**STATE SIGNIFICANT DEVELOPMENT:
Section 96(1A) Modification Application**

***SICEEP, ICC Hotel fit out, external lighting and
subdivision, Sydney***

SSD 6831 MOD 1

Environmental Assessment Report
Section 96(1A) of the *Environmental Planning
and Assessment Act 1979*

Figure 3: Podium (Level 4) showing speakers proposed (Source: Acoustic report).

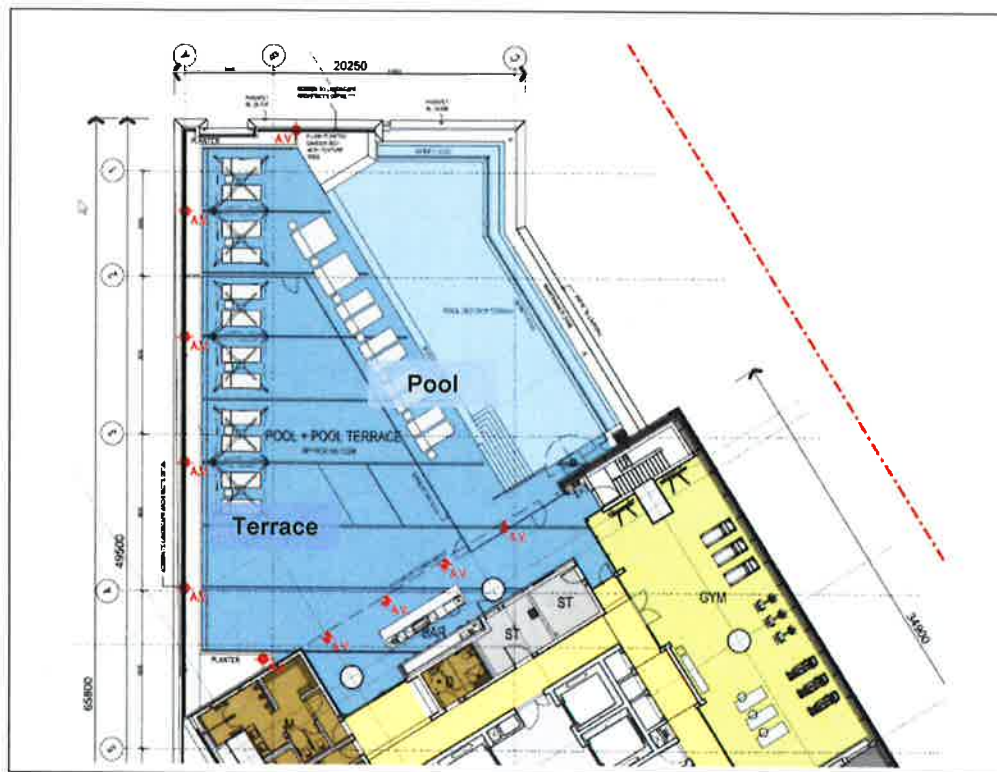
This proposal seeks approval for the installation and operation of ten speakers on level four of the outdoor terrace, bar and pool area for use for background music (**Figure 3**).

The applicant seeks to amend Condition G30 to allow for the operation of the speakers in the outdoor terrace area. The speakers are proposed to play background music at a level of 70 dB(A) measured at two metres from the speakers.

The key issue in the Department's assessment is the potential noise impacts of the use of the proposed speakers on surrounding properties, specifically the Novotel Hotel which has hotel rooms facing the terrace.

- the Novotel Hotel guest rooms are located approximately 40 metres away, on the western side of Harbour Street and the light rail line. The distance between the properties, the direction of the speakers internally and the acoustic consultant's recommendations will ensure that there are no unacceptable noise impacts during the day and no audible noise impacts during the night at Novotel Hotel

To ensure that the noise output from the speakers achieves compliance with the conditions of consent, the Department recommends that an acoustic verification report be prepared and submitted to the Department within one month of the speakers being operational, and annually thereafter, demonstrating ongoing compliance with Conditions G21 to G25. Where compliance is not achieved, the noise output of the speakers must be reduced to a level that achieves compliance and any other recommendations of the report must be implemented.

Noting the Acoustic report applied the residential noise criteria in Conditions G21, G22 and G24 to the hotel rooms, the Department recommends these conditions be amended to clarify noise generated by the hotel, including use of the speakers, needs to be managed so as it does not impact on the amenity of both surrounding residents and hotel guests.
